Frickenhausen, 4 November 2020

PRODUCT MODIFICATION: FRAMES OF 96 WELL ELISA STRIP PLATES

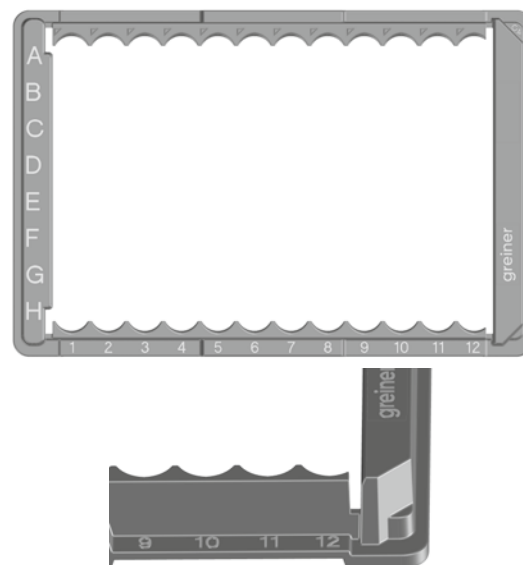
We will introduce **4 slits to the inner corners of the frame**. This helps **minimise the abrasion during the assembly** of frame and strips.
